Agenda Item C  
Agenda Date: 10/25/2016  
Supplemental #1

RE: RDCS 2016-0010 MONTEREY – DYNASTY

## RDCS 2016-0010 MONTEREY – DYNASTY (Request for 2 Units)

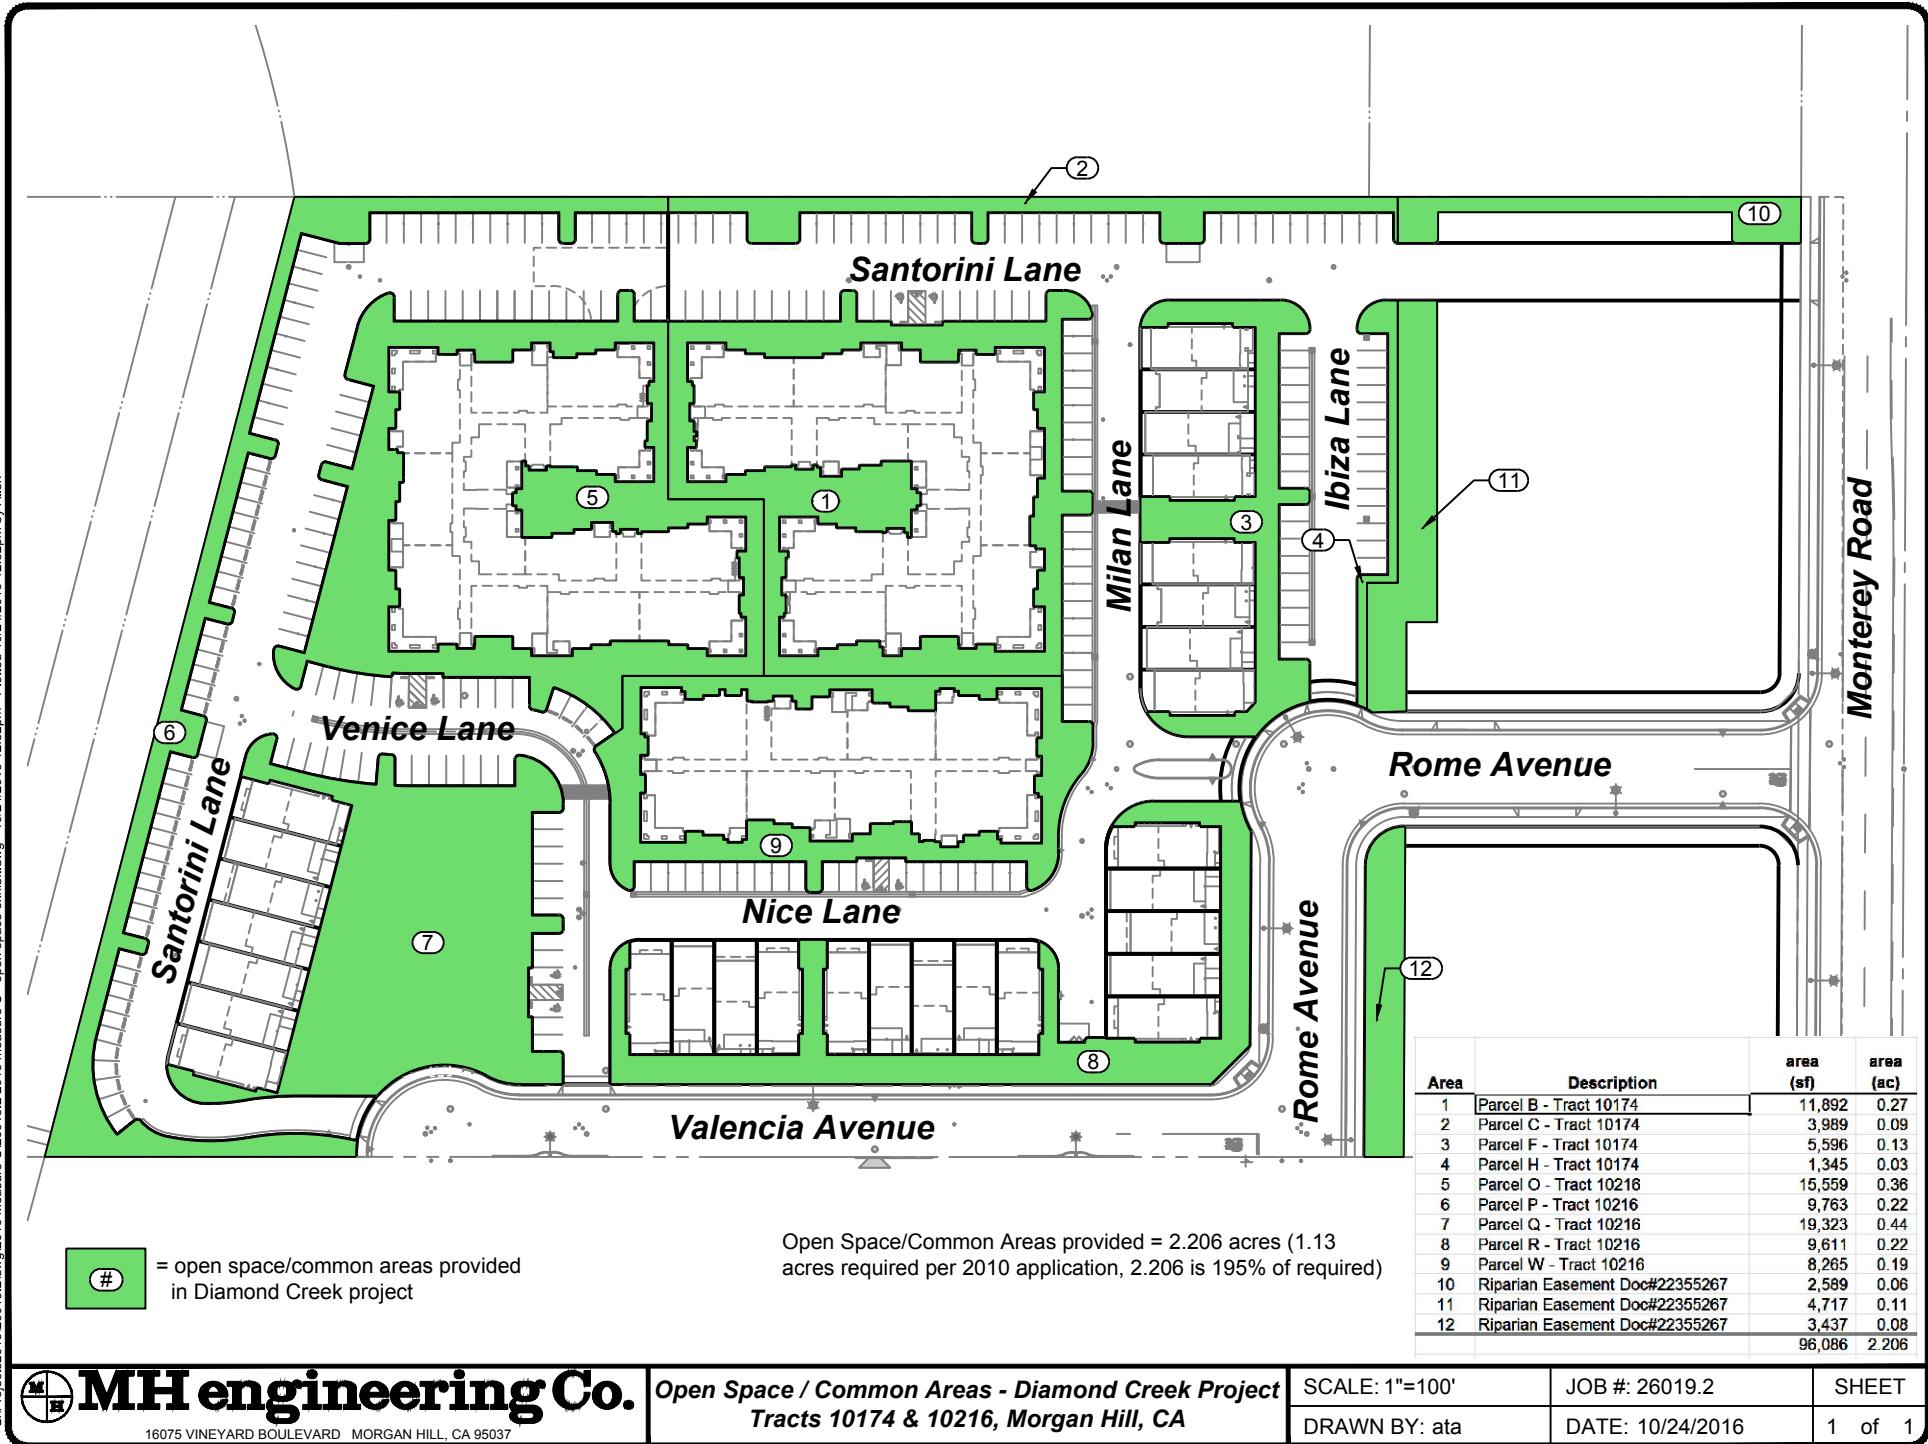
No cul-de-sacs will be needed when street stub is connected	2	The project has created a long deadend street that exceeds 850 feet.	0
b.

Applicant's project site improvement design from North side of Santorini Lane loop to west side of project, then connect through south side of Valencia Avenue and does not create dead end street in the project. Also, on south side of Valencia Avenue and Rome Avenue, there are 2 future street extensions to neighborhood lot.
